**CULLEN BAY WATERFRONT
ESTATE AND MARINA PROJECT**

**PROPOSED ADDITIONAL DREDGING FROM
THE EMERY POINT SANDBAR**

ENVIRONMENTAL ASSESSMENT REPORT

**ENVIRONMENT PROTECTION UNIT
CONSERVATION COMMISSION OF THE NT**

FIGURE 1: EMERY POINT SANDBAR

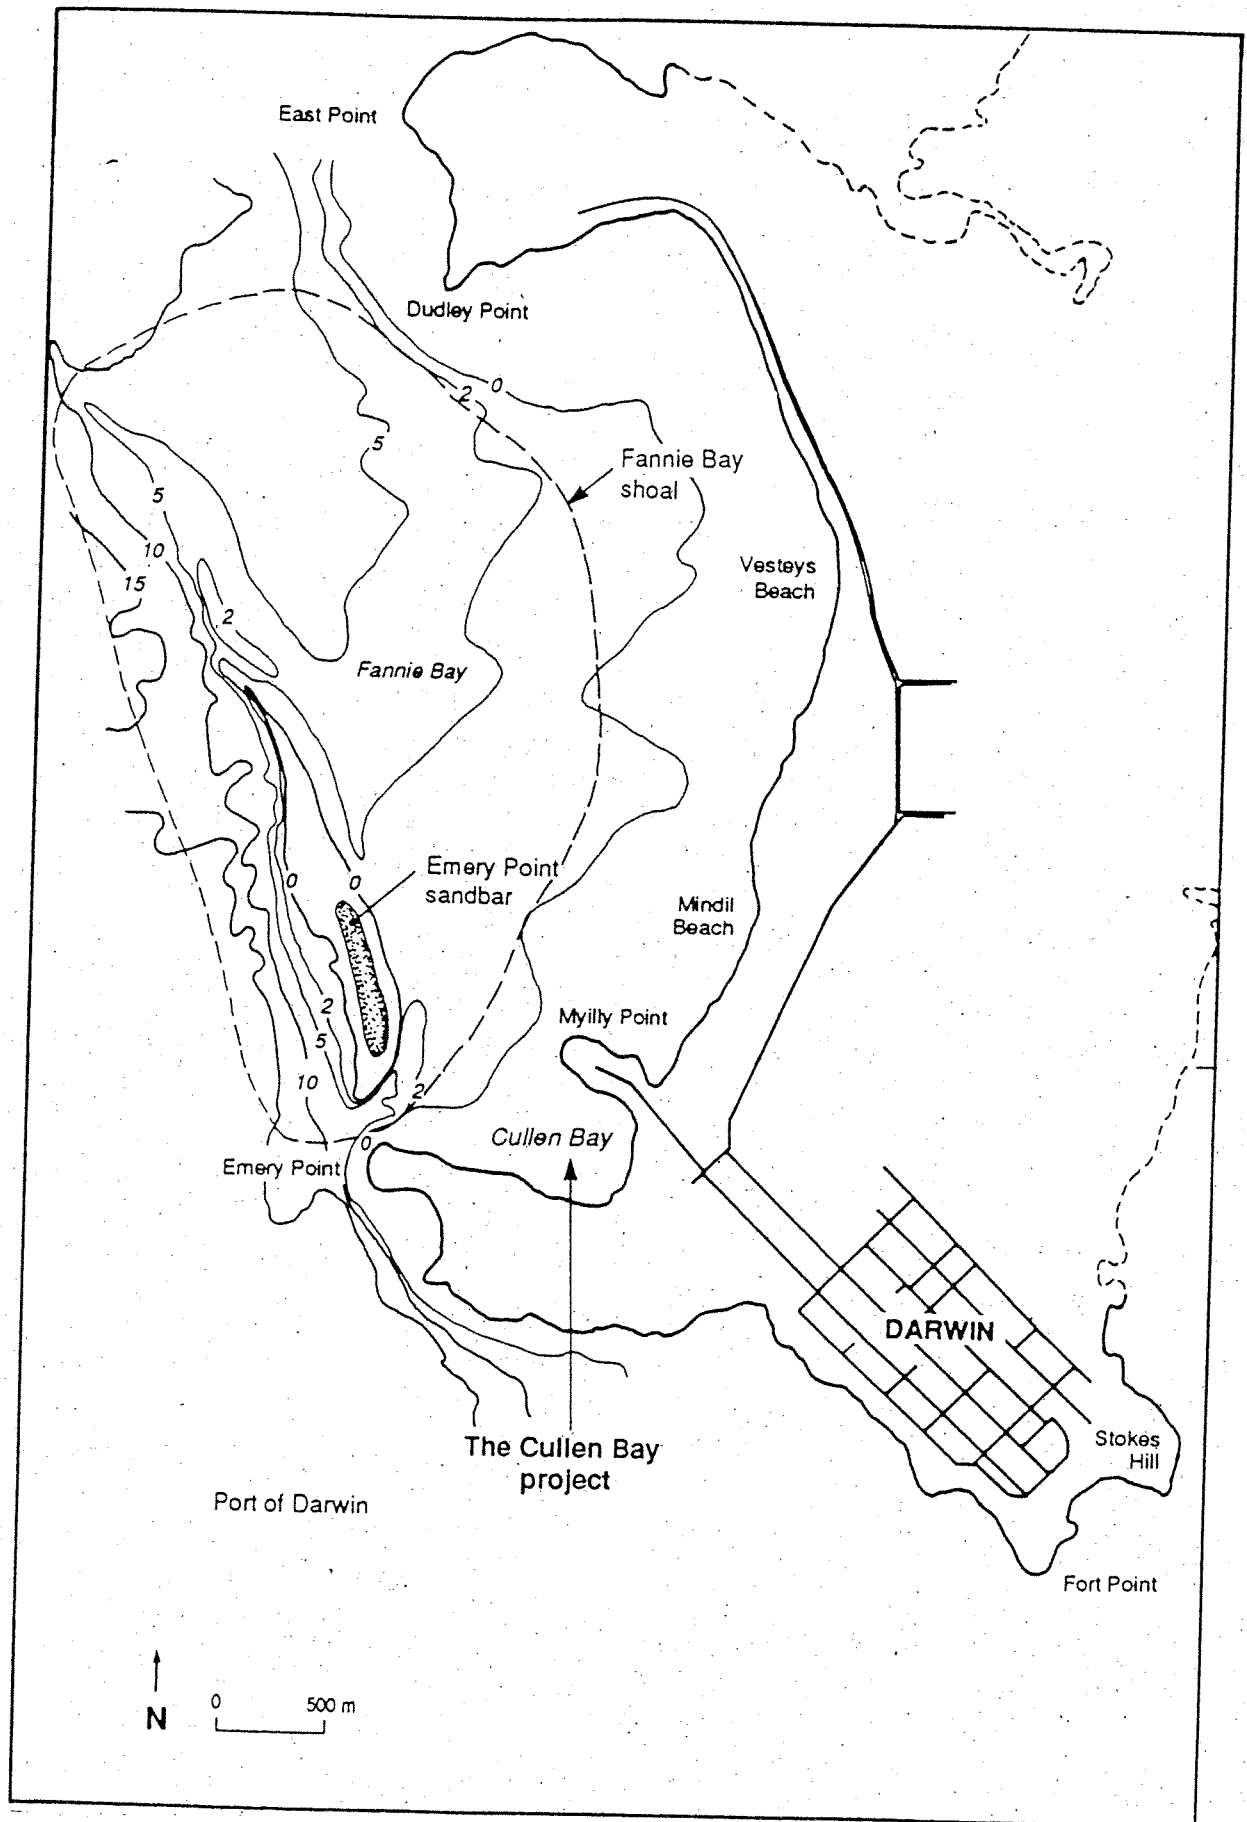
This report assesses the environmental impact of a proposal by Thiess contractors Pty. Ltd. (the proponent) to dredge additional sand from the Emery Point Sandbar of Fannie Bay, Darwin. **Figure 1** shows the location of the proposal.
